CITY OF ALBUQUERQUE

February 23, 2021

RE: **Lot 7 Block 5 Unit 19 SAD 228
6531 Azor Ln. NW
Volcano Cliffs Subdivision
Grading and Drainage Plan
Engineers Stamp Date 2/11/2021 (D10D003H7)**

ENGINEER'S SEAL 2/11/21 DAVID SOULE P.E. #14522	6531 AZOR	DRAWN BY: WCVJ
	GRADING AND DRAINAGE PLAN	DATE: 1-26-21
 1606 CENTRAL AVENUE SE SUITE 201 ALBUQUERQUE, NM 87106 (505) 872-5999		210210015-LAYOUT-2-10-21
		SHEET #
		JOB # 21021008

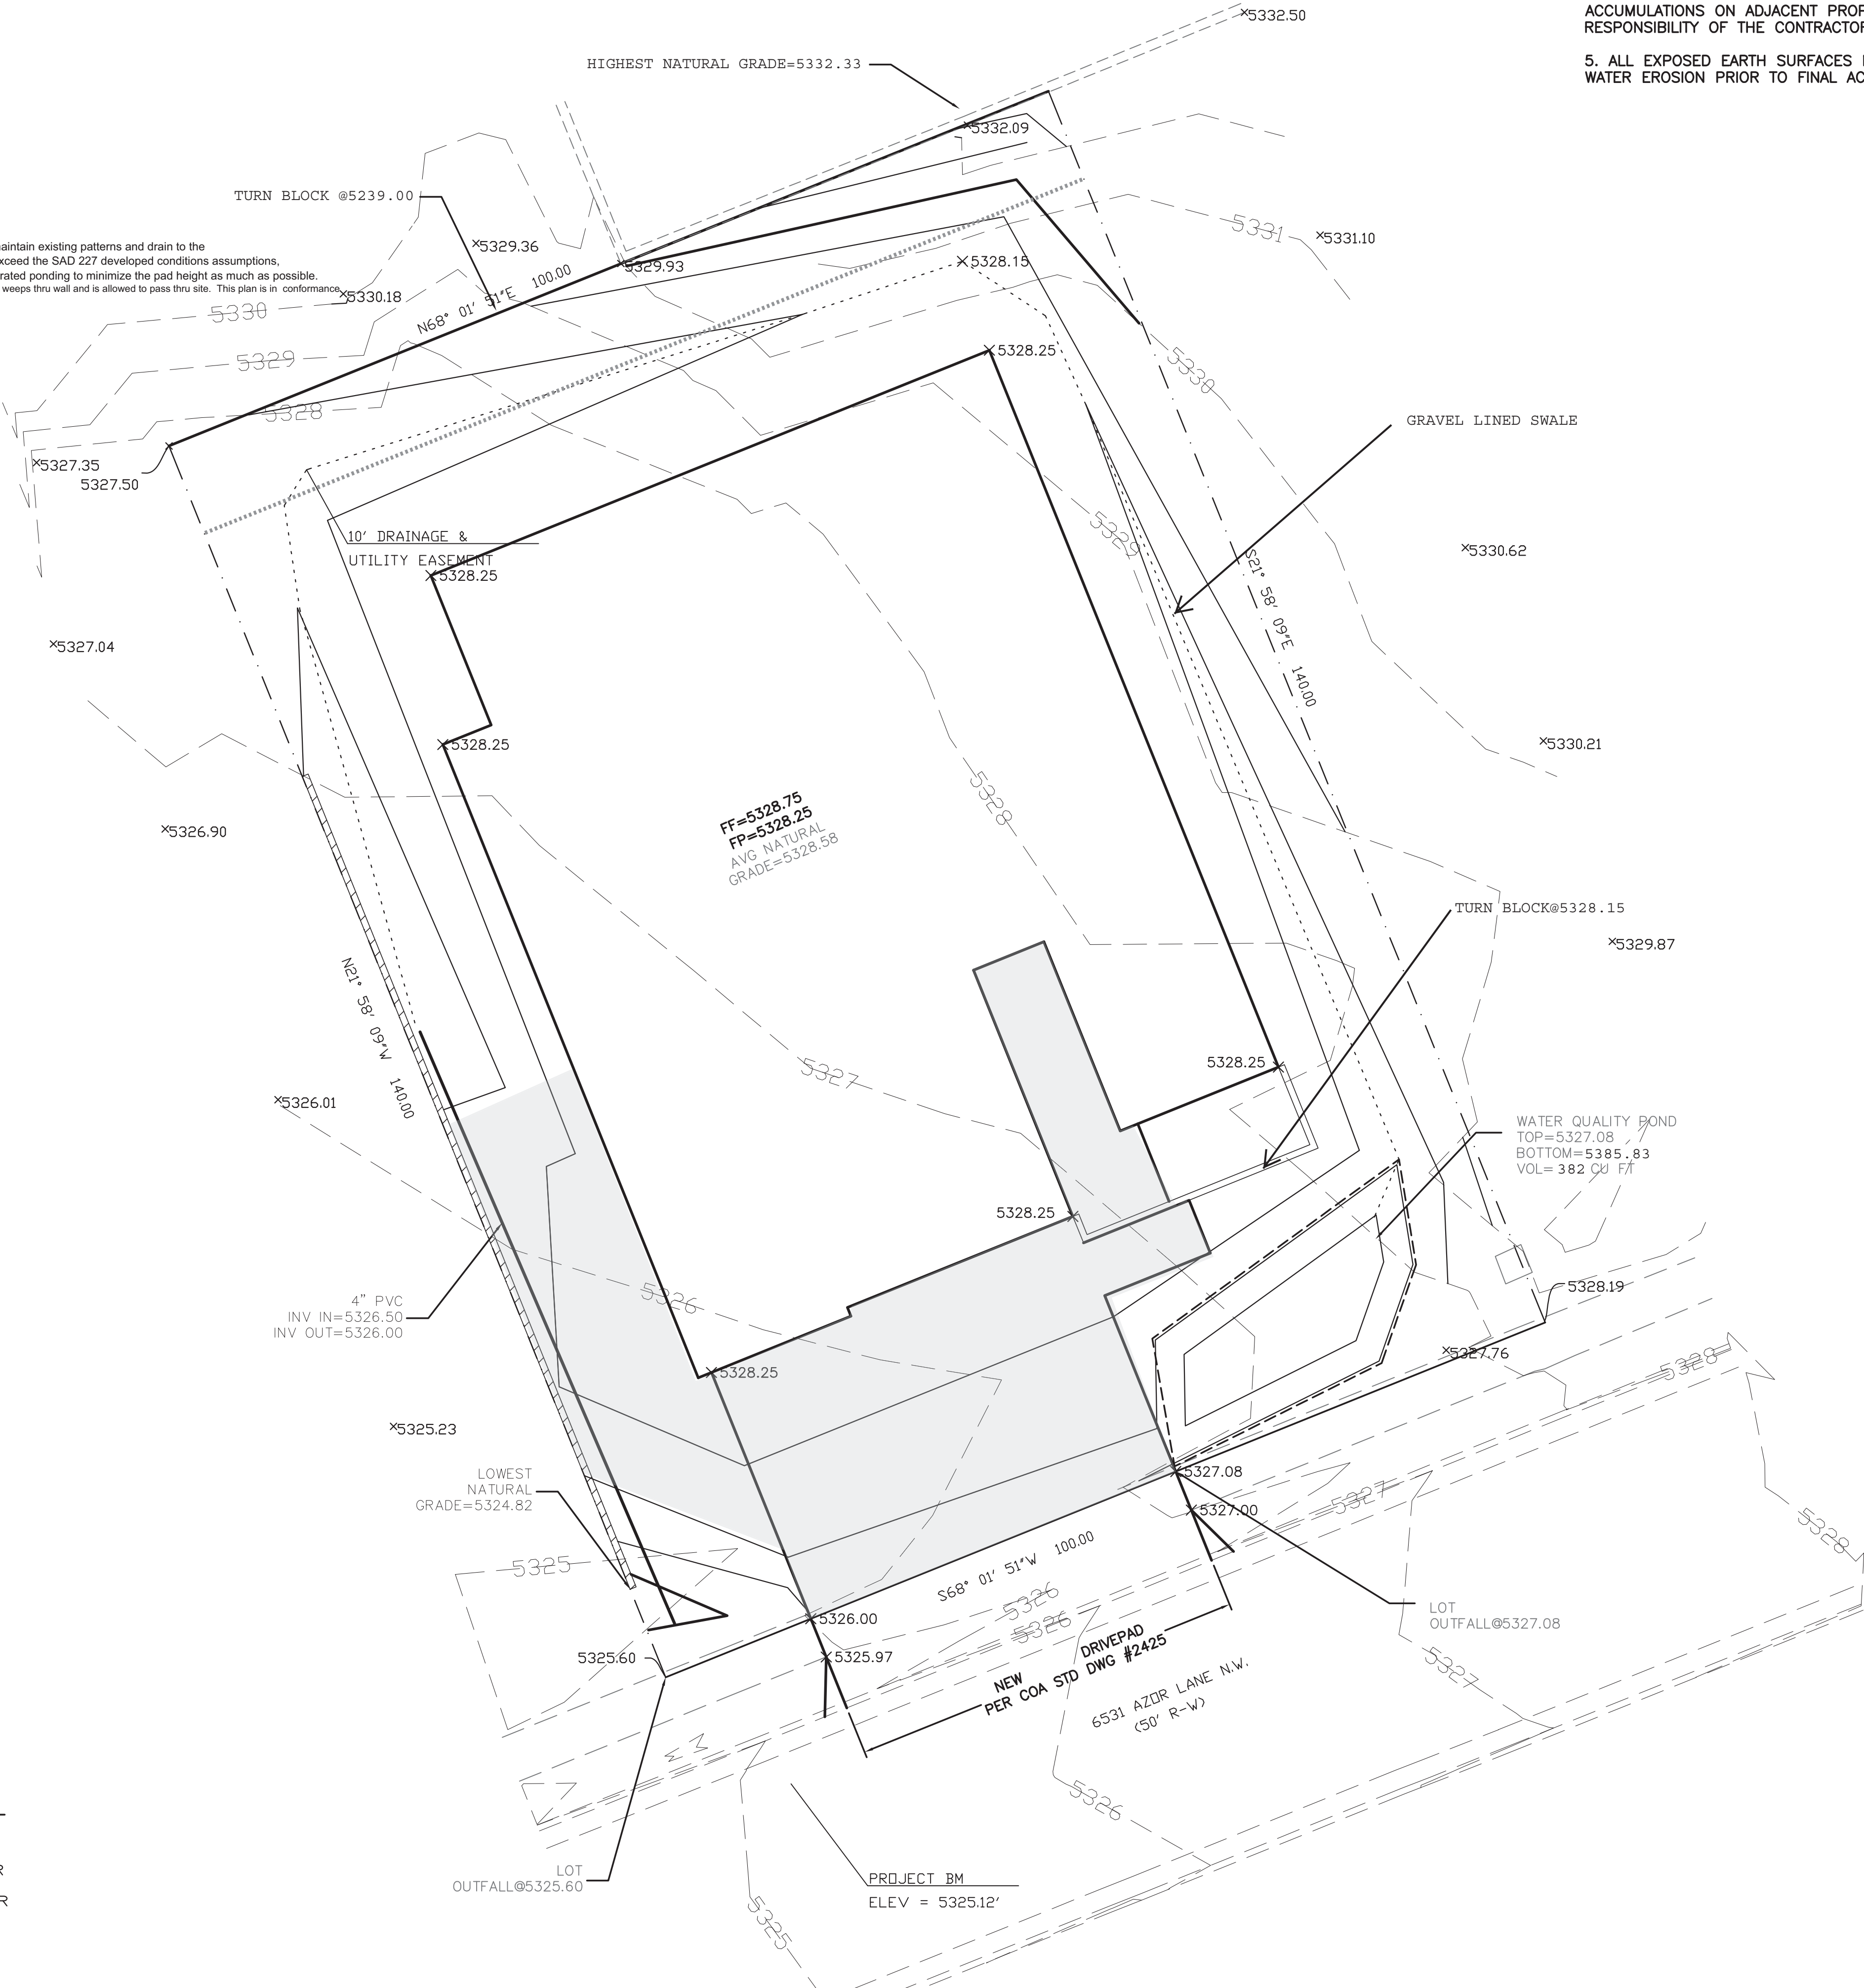
Based upon the information provided in your submittal received 2/22/2021, this plan is approved for Grading Permit.

Prior to Building permit approval a Pad Certification will be required, provided by the Engineer or a registered Land Surveyor.

Advise the owner contractor not to use dirt as a ramp to climb the curb, use lumber or crusher fines for this purpose.

Reiterate to the Owner/Contractor that a separate permit for a garden/retaining wall must be obtained with the approved G&D plan and Pad Certification. Also, if a swimming pool is to be placed the grading and drainage plan will change and will need to be resubmitted.

Prior to Certificate of Occupancy release, Engineer Certification per the DPM checklist is required.
